Access Compliance Report

Public Rights-of-Way

(Curb Ramps)

Intersection ID: 11330	Main Street: FLAMINGO_AV	Cross Street: PALM_AV	Location: SE
ADA ID: 5128FC1A0A76	Ramp Type: Perp	Initial Pass/Fail: Fail	Overall Compliance: No
Codes/Mitigation Info/Possible Solution		Field Measurements/Component Compliance	
Severity Score: 21.25

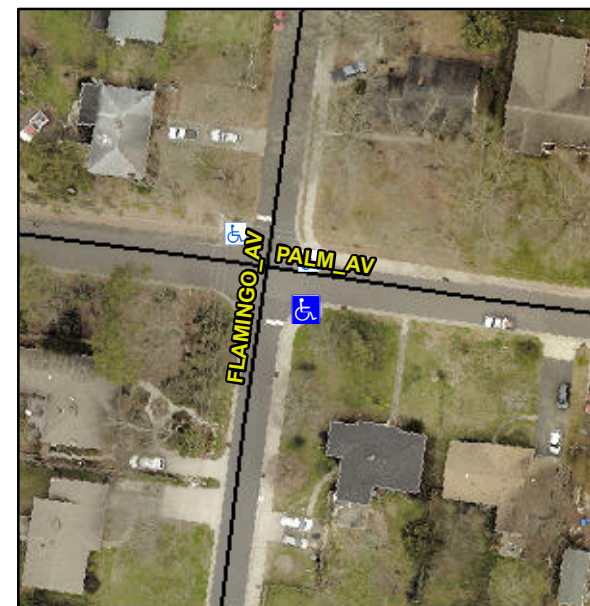
Not Found, R304.5.1, R304.5.3

Compliance	Description	Data	Compliance	Description	Data
N/A	Ramp Length (in)	67.5	Yes	Ramp Slope (%)	5.6
No	Ramp Width (in)	40.0	No	Ramp XSlope (%)	6.9
N/A	Flare Type LT	N/A	N/A	Flare Type RT	N/A
N/A	Flare Slope LT (%)	N/A	N/A	Flare Slope RT (%)	N/A
N/A	Flare Traversable LT?	N/A	N/A	Flare Traversable RT?	N/A
N/A	Landing Length (in)	N/A	N/A	DWS Provided?	N/A
N/A	Landing Width (in)	N/A	N/A	DWS Contrast?	N/A
N/A	Landing Slope (%)	N/A	N/A	DWS Length (in)	N/A
N/A	Landing X Slope (%)	N/A	N/A	DWS Full Width?	N/A
N/A	Landing Curb? (Y/N)	N/A	N/A	DWS Offset (in)	N/A
N/A	Shared Landing?	N/A			
N/A	Gutter Ponding?	N/A	N/A	Gutter Slope (%)	N/A
N/A	Gutter Lip Ht (in)	N/A	N/A	Gutter X Slope (%)	N/A
N/A	Painted X Walk1?	No	N/A	Painted X Walk2?	N/A
	X Walk 1 Direction	To N		X Walk 2 Direction	N/A
N/A	X Walk 1 Width (in)	N/A	N/A	X Walk 2 Width (in)	N/A
	X Walk 1 Slope (%)	5.0		X Walk 2 Slope (%)	N/A
	X Walk 1 X Slope (%)	4.0		X Walk 2 X Slope (%)	N/A

Remove & Replace Entire Ramp.
